SUBJECT: WATTS BAR NUCLEAR PLANT, UNIT 1 - STAFF ASSESSMENT OF INFORMATION PROVIDED PURSUANT TO TITLE 10 OF THE *CODE OF FEDERAL REGULATIONS*, SECTION 50.54(f), SEISMIC HAZARD REEVALUATIONS RELATING TO RECOMMENDATION 2.1 OF THE NEAR-TERM TASK FORCE REVIEW OF INSIGHTS FROM THE FUKUSHIMA DAI-ICHI ACCIDENT (TAC NO. MF3769)

STAFF ASSESSMENT BY THE OFFICE OF NUCLEAR REACTOR REGULATION

RELATED TO SEISMIC HAZARD AND SCREENING REPORT

WATTS BAR NUCLEAR PLANT, UNIT 1

**Figure 3.3-1 Plot of Staff's and Licensee's Base Case Shear-Wave Velocity Profiles for the Watts Bar, Unit 1 site**

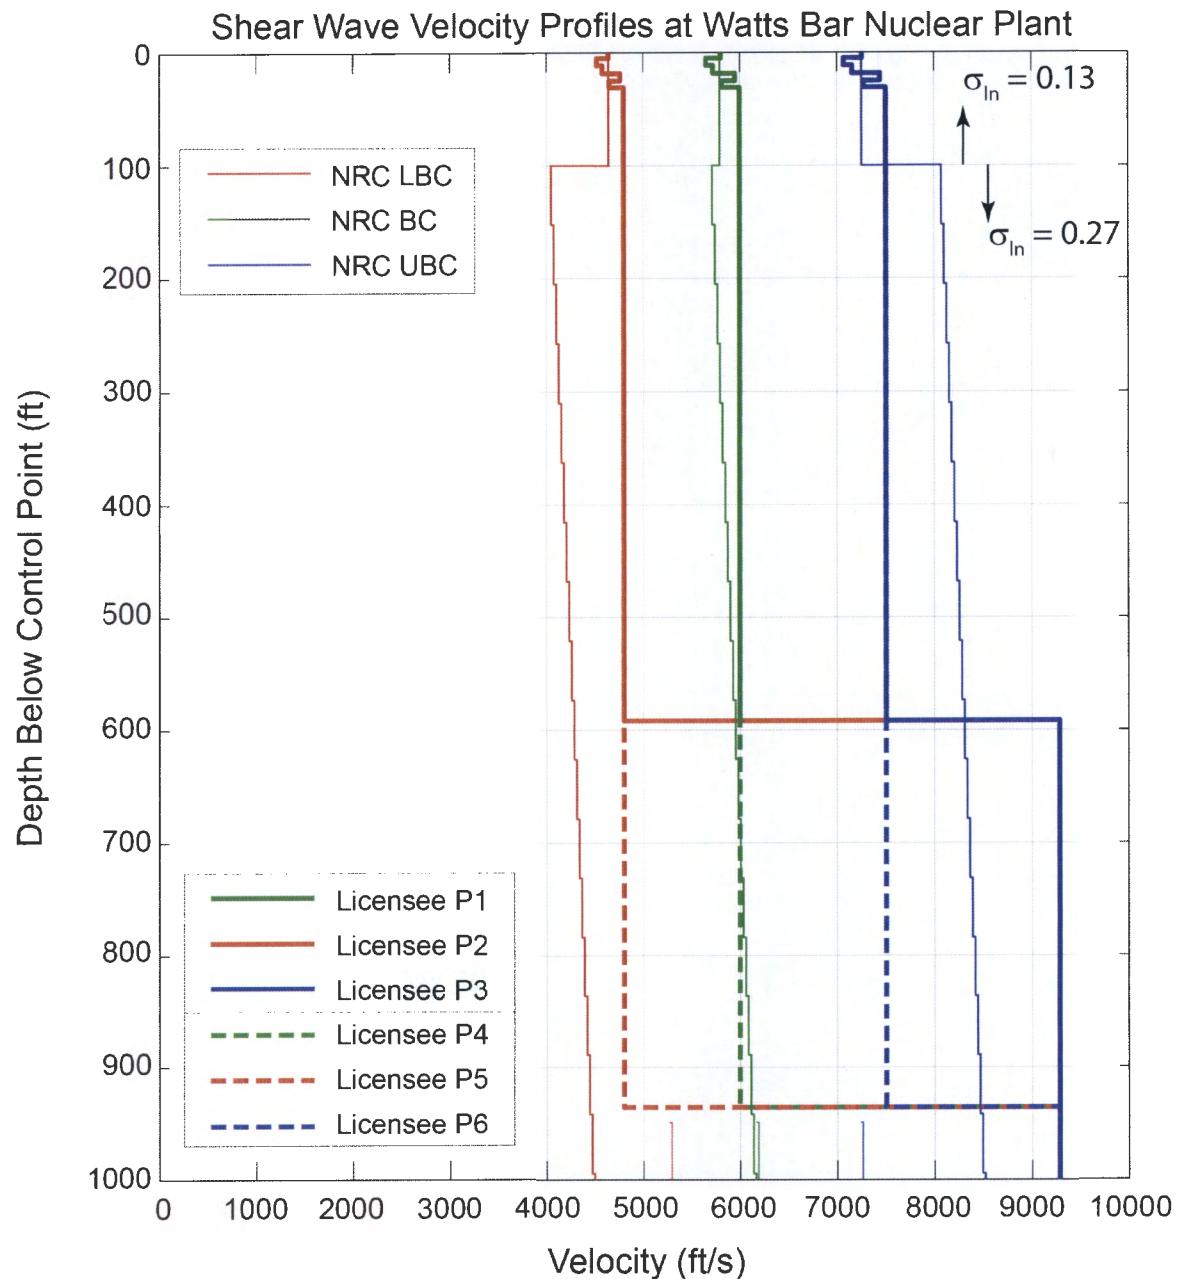
Figure 3.3-1 of this assessment shows the NRC staff velocity profiles compared to those developed by TVA. TVA developed two sets of three velocity profiles with varying depth-to-reference rock to account for the strata dip under the footprint of the plant, whereas the NRC staff used only one set of three profiles and placed the bedrock boundary at a depth of 1000 ft [305 m] below the control point. The near-surface (top 100 ft [31 m]) base-case velocity profiles are similar. However, below 100 ft [31 m] the spread in the NRC staff's velocity profiles is larger due to implementation of a larger epistemic uncertainty. In addition, the NRC staff's velocity profiles increase linearly with depth following the SPID guidance, whereas, TVA used a constant velocity with depth.

**Figure 3.3-2 Plot Comparing the Staff's and TVA's Median Amplification Functions and Uncertainties for the Watts Bar, Unit 1 site**

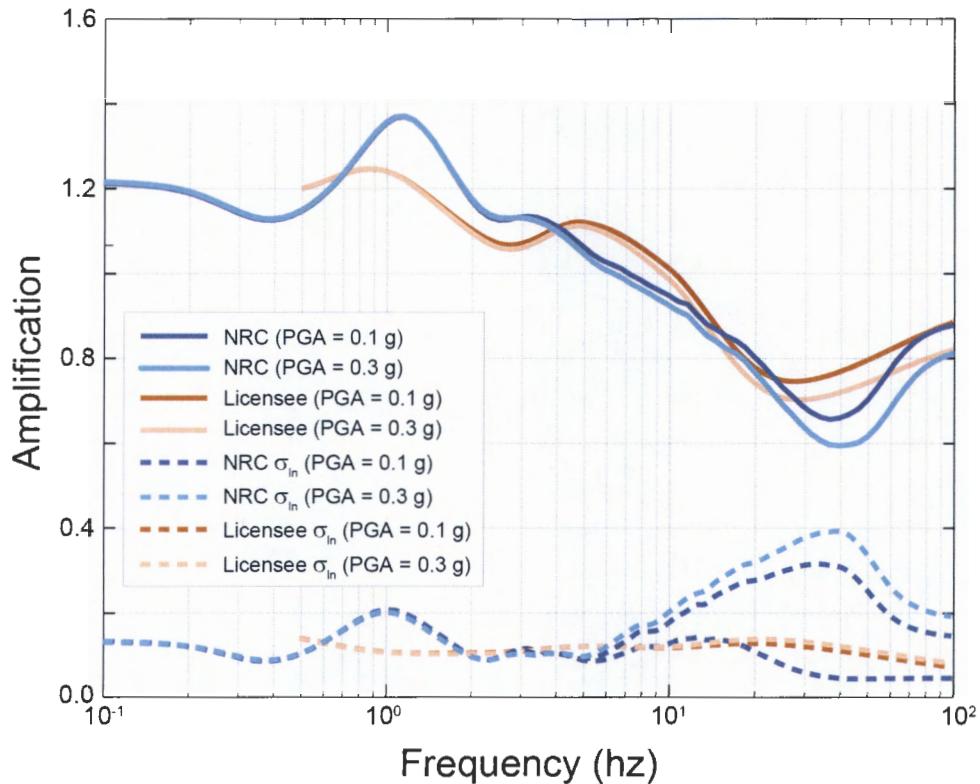
Figure 3.3-2 of this assessment shows a comparison of the NRC staff's and TVA's median site amplification functions and uncertainties for two of the eleven input loading levels. As shown in this figure, TVA's amplification functions are slightly lower below 4 Hz, and, on average, slightly higher above 4 Hz. The differences in the amplification function at lower frequencies (~ 1Hz) could be due to TVA using an additional set of three velocity profiles P1, P2, and P3, which has broadened the peak response. However, the NRC staff finds that these small differences are acceptable for this application because they are within the limits of the uncertainties.

**Figure 3.3-3 Plot Comparing the Staff's and TVA's Mean Control Point Hazard Curves at a Variety of Frequencies for the Watts Bar, Unit 1 site**

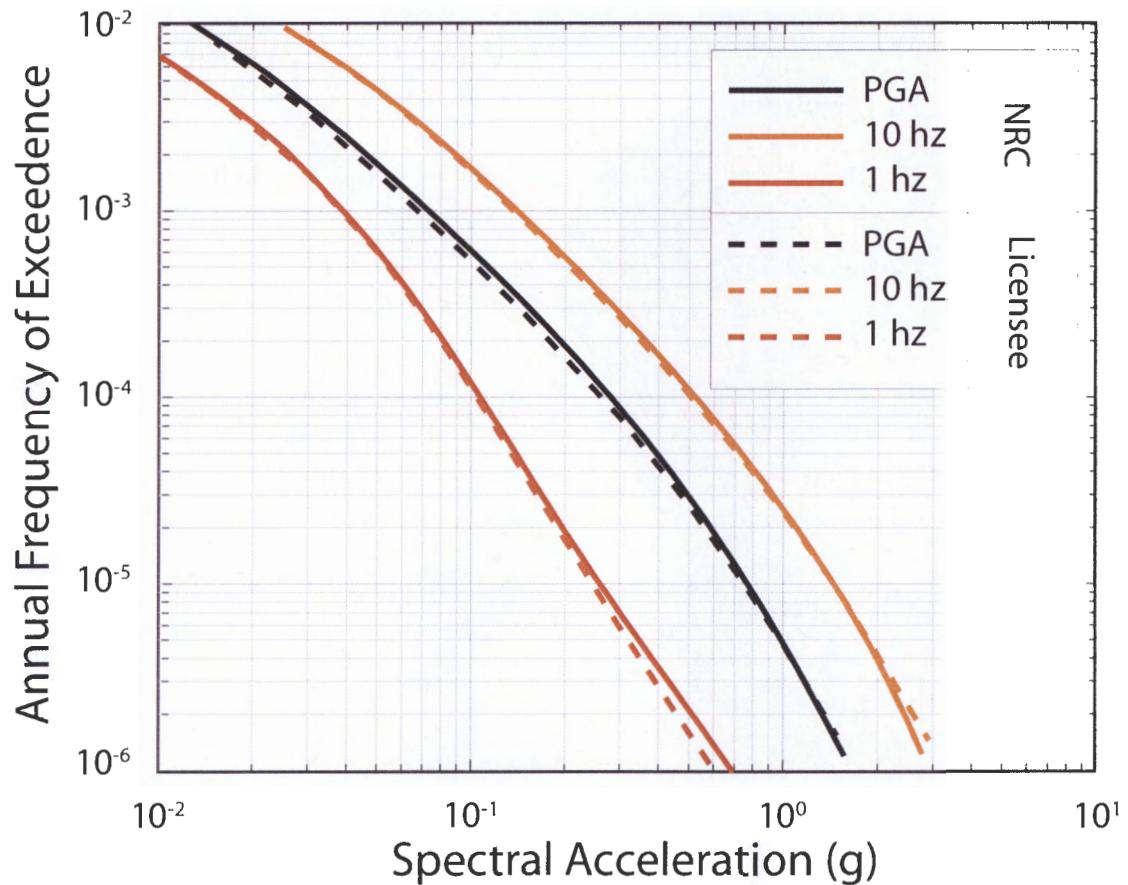
Overall, TVA's approach to modeling the subsurface rock properties and their uncertainty results in similar site amplification factors as those developed independently by the NRC staff. In addition, as shown in Figure 3.3-3 of this assessment, the soil hazard curves developed by TVA and the NRC staff at 1 Hz, 10 Hz, and PGA are very similar. Appendix B of the SPID provides guidance for performing site response analyses, including capturing the uncertainty for sites with less subsurface data; however, the guidance is neither entirely prescriptive nor comprehensive. As such, the NRC staff finds that alternative approaches in performing site response analyses, including the modeling of uncertainty, are acceptable for this application.

**Figure 3.4-1 Comparison of the Staff's GMRS, Licensee's GMRS, and the SSE for the Watts Bar, Unit 1 site**

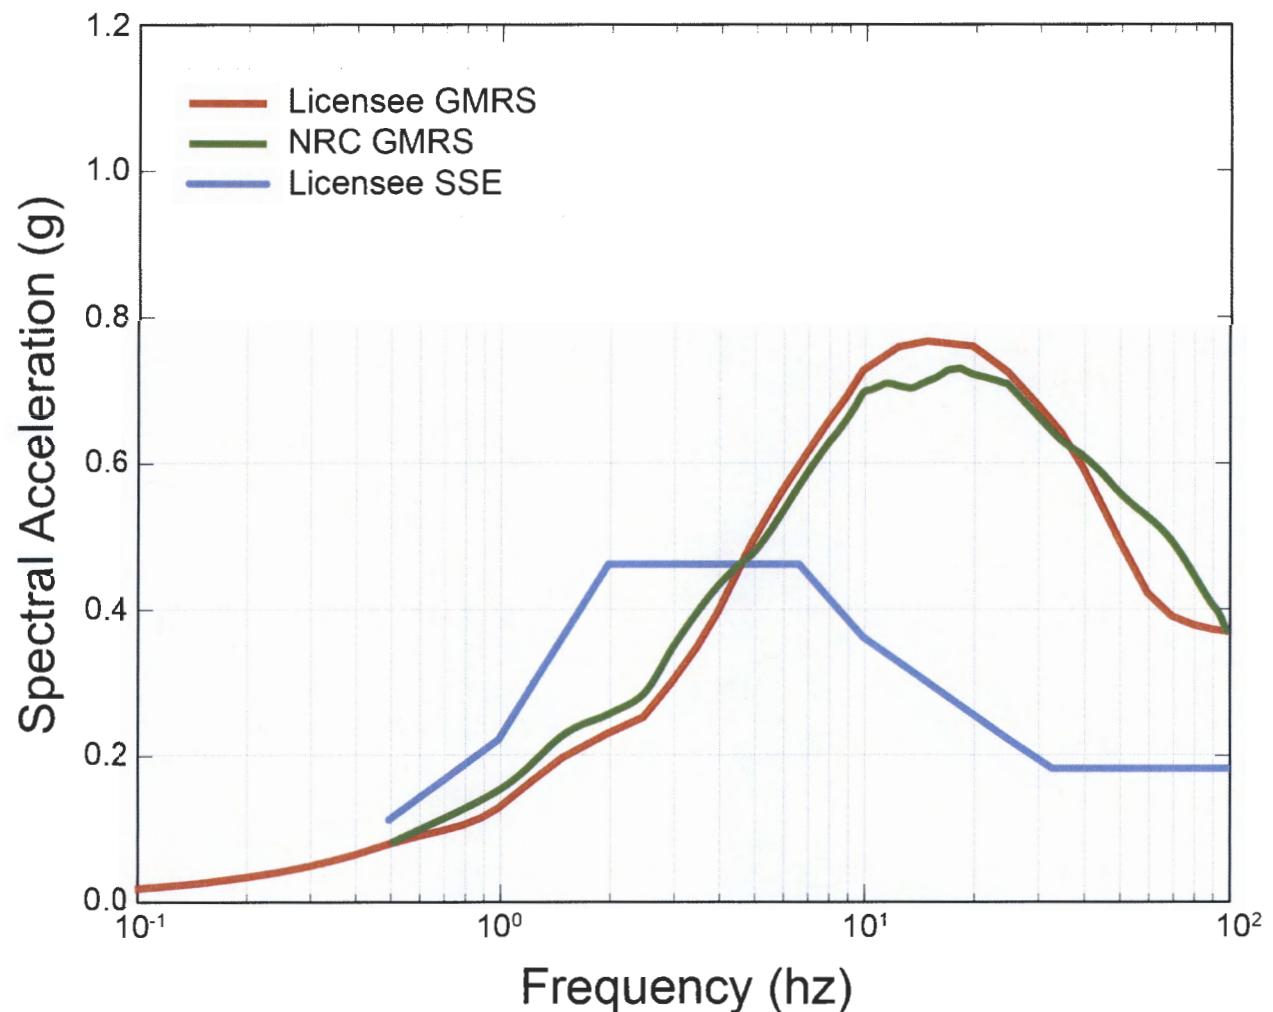
assessment, respectively. Figure 3.4-1 of this assessment shows a comparison of the GMRS determined by TVA to that determined by the NRC staff.

As shown in Figure 3.4-1 of this assessment, TVA's GMRS shape is generally similar to that calculated by the NRC staff at frequencies less than 10 Hz. However, the NRC staff's confirmatory GMRS is somewhat lower than TVAs at 10-40 Hz, and slightly higher above 40 Hz. As described in Section 3.3 of this assessment, the NRC staff concludes that these minor differences over the higher frequency range are primarily due to the differences in the site response analyses performed by TVA and NRC staff. The NRC staff concludes that these differences are acceptable for the response to the 50.54(f) letter because TVA followed the guidance provided in the SPID with respect to both the PSHA and site response analysis for the Watts Bar, Unit 1 site.

The NRC staff confirmed that TVA used the present-day guidance and methodology outlined in RG 1.208 and the SPID to calculate the horizontal GMRS, as requested in the 50.54(f) letter. The NRC staff performed both a PSHA and site response confirmatory analysis and achieved results consistent with TVA's horizontal GMRS. As such, the NRC staff concludes that the GMRS determined by TVA adequately characterizes the reevaluated hazard for the Watts Bar, Unit 1 site. Therefore, this GMRS is suitable for use in subsequent evaluations and confirmations, as needed, for the response to the 50.54(f) letter.
